PLANNING COMMITTEE

Amendment Sheet.

P/02411/022 – Thames Central, Hatfield Road, Slough, SL1 1QE

First Floor (Level 2)

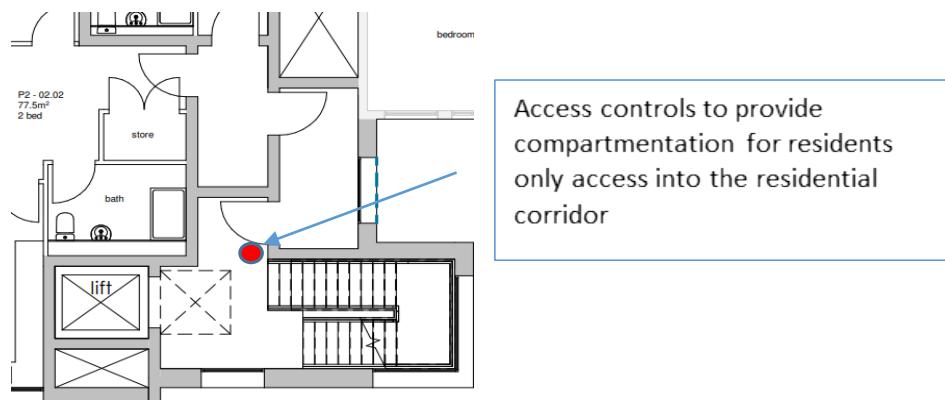
This appears to include the cycle storage for all occupants. Formal surveillance should be present in this location.

This floor introduces access to two other cores. Merged cores should generally be avoided as they benefit those intent on crime and anti-social behaviour providing circular free movement within a development and several routes to and from an offence. Therefore, this floor represents a significant risk in terms of crime and anti-social behaviour, again this could be mitigated with robust access controls and formal surveillance.

Secured by Design highlights the importance of compartmentation in large developments and provides some guidance. The applicant must not make the mistake of considering all offenders being external to a development. Neighbourhood disputes impact heavily police resources. Occupants should only have access to areas within the development that they have a legitimate need to access, e.g. a resident located on the 9th floor should have access through the communal doors, to mail services, to the parking and cycle storage areas, to the appropriate stair and lift core to access their floor and the floor plate of the level 9. They should not have access to other stair cores or floor plates and should be treated like a visitor should they wish to gain entry at these points.

The applicant therefore needs to address compartmentation of the development through their access controls, how visitor entry will be facilitated and where these entry systems will be located.

1. It is proposed to use a programmable key fob access control system throughout the building.
2. Secure key fob access will be provided at first floor level to the circulation cores.
3. Access at each floor level (2nd floor upwards) will be limited to the residents of each floor by way of a secure access lobby.

4. A management suite has now been located at first floor level allowing visual monitoring of both the vehicular access and the pedestrian access. Whilst there is no view to the west this could if necessary be provided by way of an additional window as noted on the attached mark-up.
